Title		aLIGO TCS Interlock Circuit	
Size:	C	DCC Number:	D1101835
Drawn by:	Shao & Steve	Date:	1/28/2014
File:	C:\ControlRoom\ASICS\TCS_ShiftContr_COOL_Laser\9-17-2012\10-17-AM\TCS_20090901_Sheet 3-1864.dwg	Revision:	v6
		Ligo Project California Institute of Technology Massachusetts Institute of Technology

aLIGO TCS Interlock
D1101835_V6
SN [REDACTED]

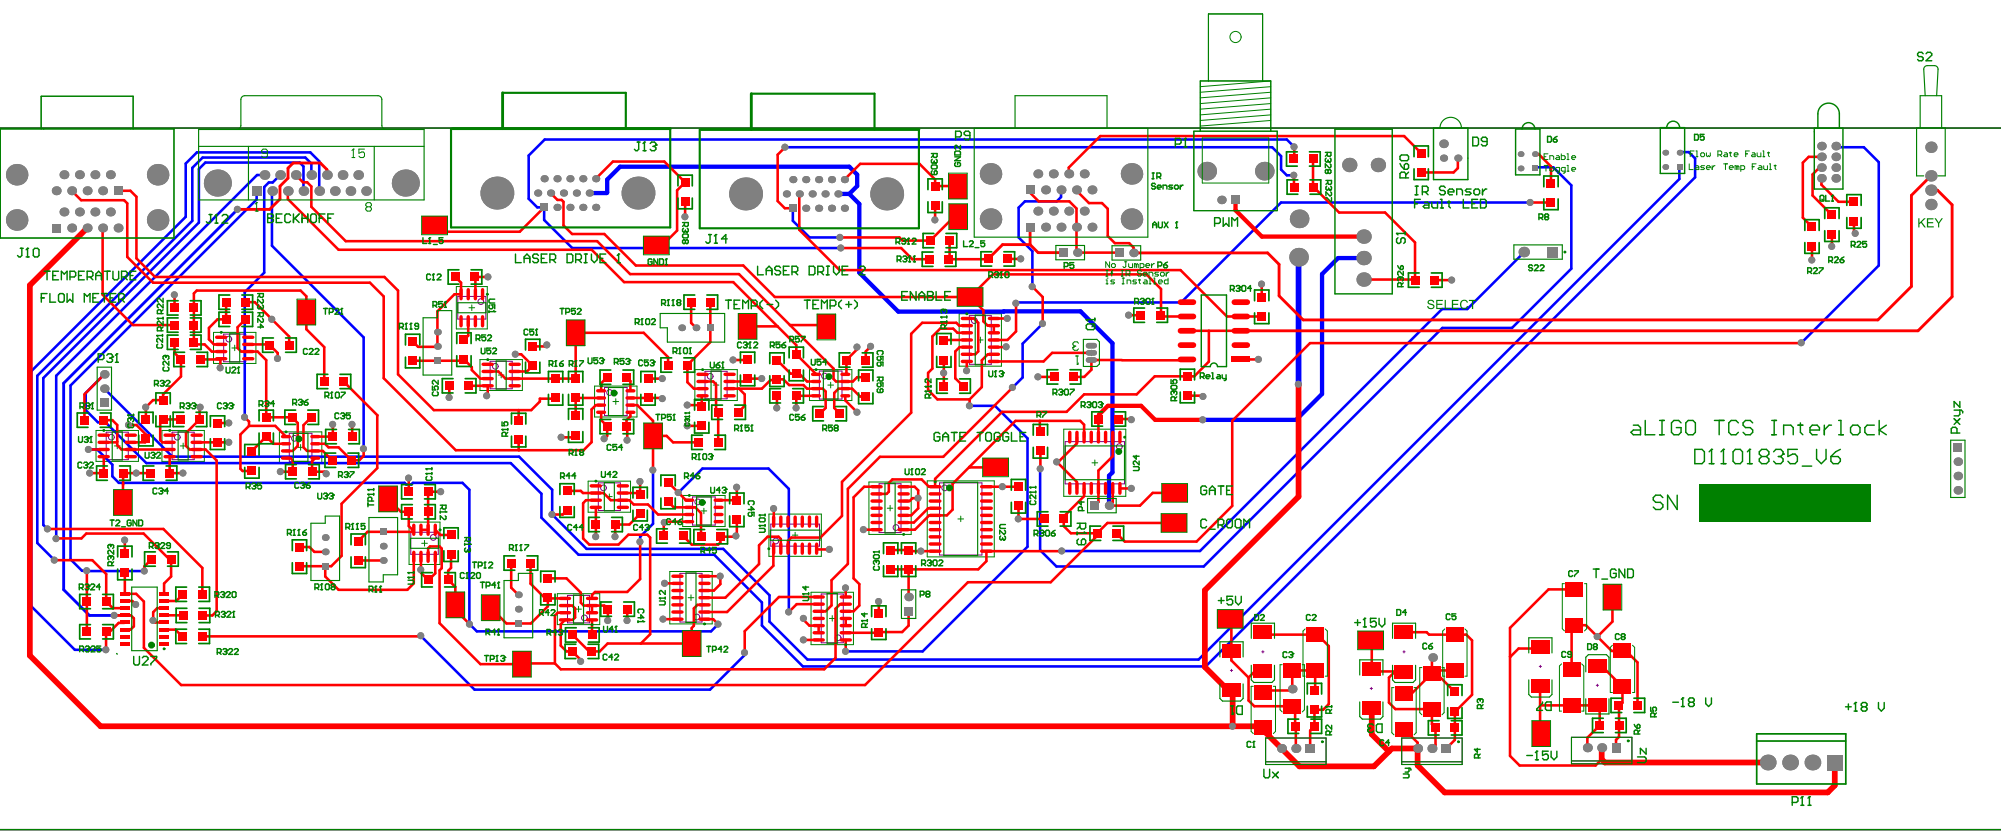
In v6, R115 was changed from 6.65K to 4.87K to match the flowmeter signal better.

In v6, R24 was changed from 4.02K to 1K to better match the ADC input level of +/- 10V.

In v6, R45 was removed to change the gain of U43 from 2 to 1.
